**Monks Orchard Residents'
Association
Planning**

Reference:	22/03888/FUL
Application Received:	Tue 20 Sep 2022
Application Validated:	Tue 20 Sep 2022
Address:	9 - 13 Gladeside Croydon CR0 7RL
Proposal:	This proposal is for the demolition of 3no existing dwellings and the erection of 7no dwelling houses of two storey with accommodation in the roof space. 11 car parking spaces are provided including 1no accessible space plus cycle and refuse storage.
Status:	Awaiting decision
Case Officer	Christopher Grace
Consultation Expiry:	Sun 16 Oct 2022
Determination Deadline:	Tue 15 Nov 2022

Please accept the following assessment by MORA of the Planning Application proposal Application Reference 22/03888/FUL at: 9–13 Gladeside Croydon CR0 7RL for the demolition of 3no existing dwellings and the erection of 7no dwelling houses of two storey with accommodation in the roof space. 11 car parking spaces are provided including 1no (*Disabled*) space plus cycle and refuse storage.

Failure to meet the 45 Degree (Verticle) Rule

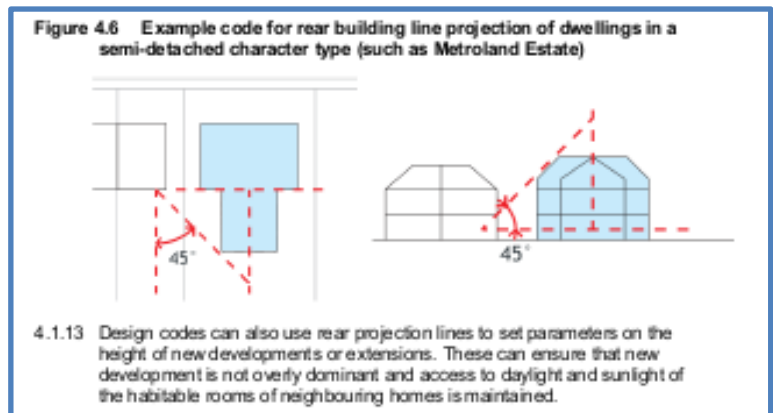
7.2 The proposed **Unit 1** will not meet the **45° Vertical Rule** projection from the centre of nearest ground floor window of **No. 7 Gladeside** resulting from the varying ground levels and height of the proposed development.
